## COLLABORATIVE AEROSPACE RESEARCH CENTER DESIGN

PROJECT NUMBER: 2399-23

### ADDENDUM NO. 1

ISSUE DATE: March 25, 2024

5/29/23 MARKUPS BY ROWELL BROKAW

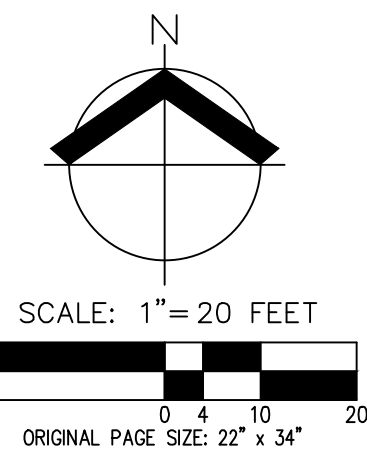
PROPOSED TRANSFORMER LOCATION AT HIGHER ELEVATION. CLEARANCES SHOWN HATCHED. TRANSFORMER WILL SIT ON 72"x51" CONCRETE VAULT.

NEW ELECTRICAL ROOM LOCATION REQUIRED WITH NEW SERVICE
